Docket Number:	23-OPT-01
Project Title:	Fountain Wind Project
TN #:	248313
Document Title:	scoping report part2
Description:	N/A
Filer:	Caitlin Barns
Organization:	Stantec Consulting Services, Inc.
Submitter Role:	Applicant Consultant
Submission Date:	1/4/2023 11:59:01 AM
Docketed Date:	1/4/2023

Appendix G

Public Scoping Meeting Transcript

In The Matter Of:
SCOPING SESSION FOR THE FOUNTAIN WIND PROJECT
(Use Permit No. UP 16-007)

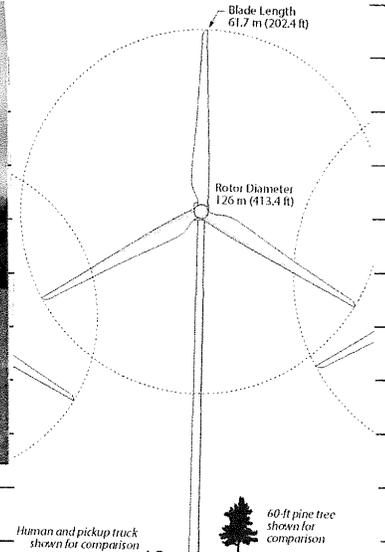
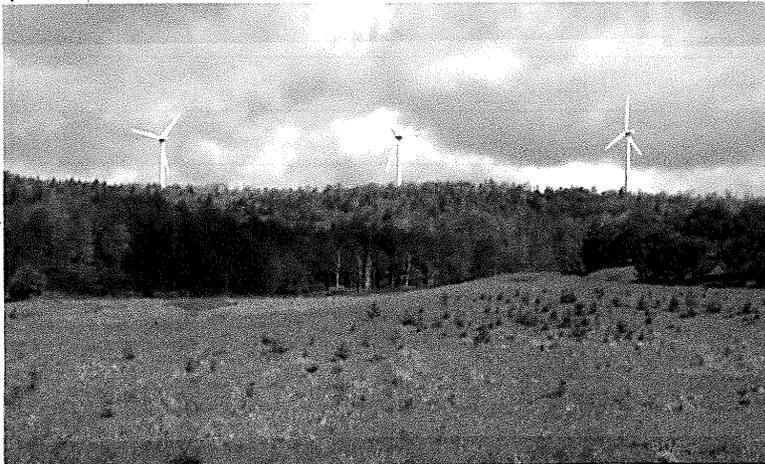
Comment: I chose pictures to emphasize my comment: How can 100 of these giant wind turbines do anything but totally dominate the visual and atmospheric landscape of our beautiful mountain forest region?

3.45 MW Turbine
Tower height: 117 m (383.9ft)
Total tip height: 180 m (590.6 ft)
